**Minutes of the North Carolina Building Code Council**  
**January 28, 2019**  
**Raleigh, NC**

**FIGURE AM109.1(1)**  
**NO LATERAL BRACING** (No Change)

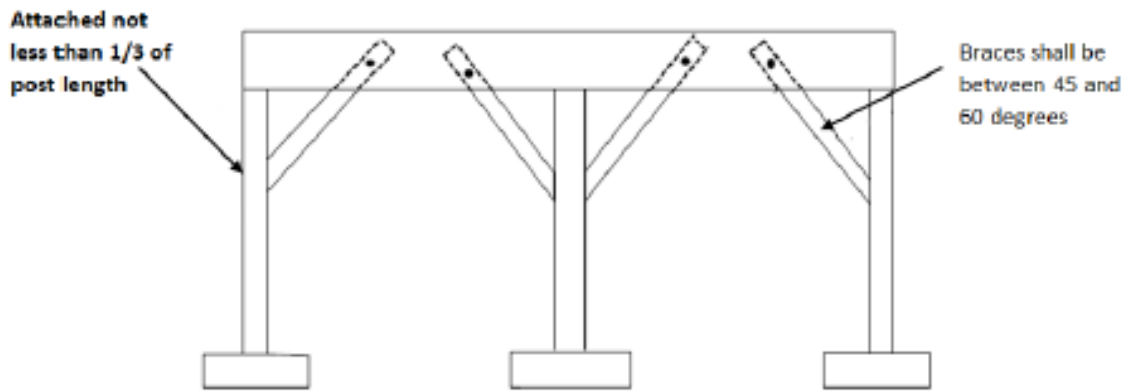
When the deck floor height is less than 4 feet (1219 mm) above finished grade as shown in Figure AM109.1(1) and the deck is attached to the structure in accordance with Section AM104, lateral bracing is not required. Lateral bracing is not required for freestanding decks with a deck floor height 30 inches (762 mm) or less above finished grade.

**FIGURE am109.1(3) (No Change)**

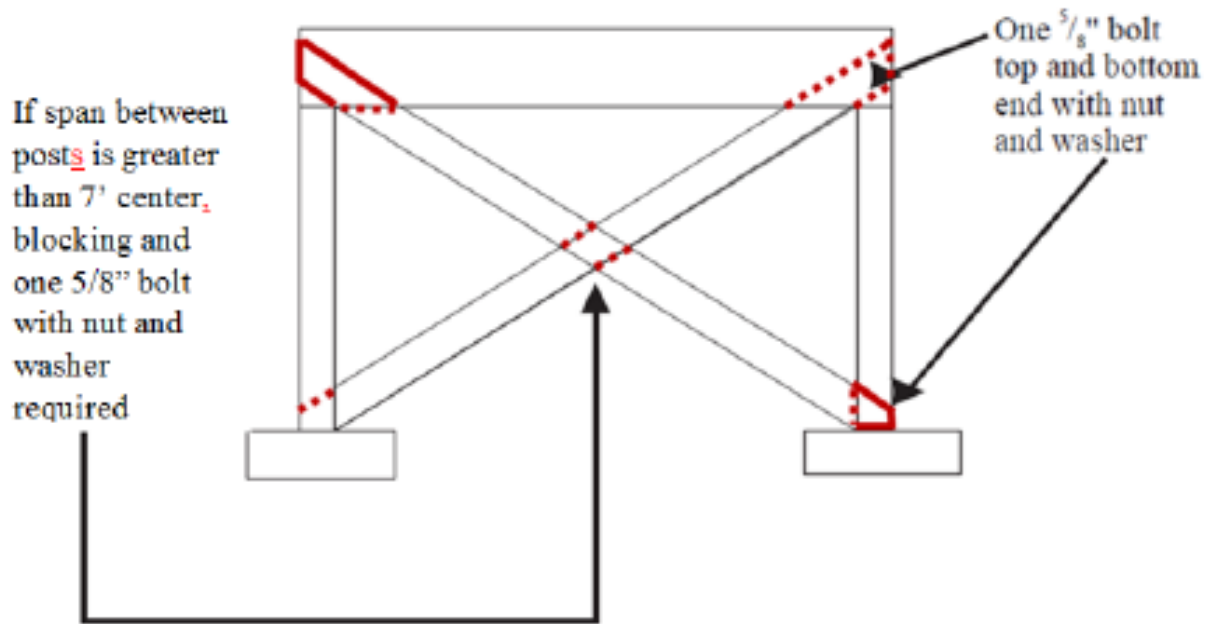
For free standing decks without knee braces or diagonal bracing, lateral stability is permitted to be provided by embedding the post in accordance with Figure AM109.1(3) and Table AM109.4<sub>2</sub>.

<b>POST SIZE</b>	<b>MAXIMUM TRIBUTARY AREA</b>	<b>MAXIMUM POST HEIGHT</b>	<b>EMBEDMENT DEPTH</b>	<b>CONCRETE DIAMETER</b>
4" x 4"	48 SF	4'-0"	2'-6"	1'-0"
6" x 6"	120 SF	6'-0"	3'-6"	1'-8"
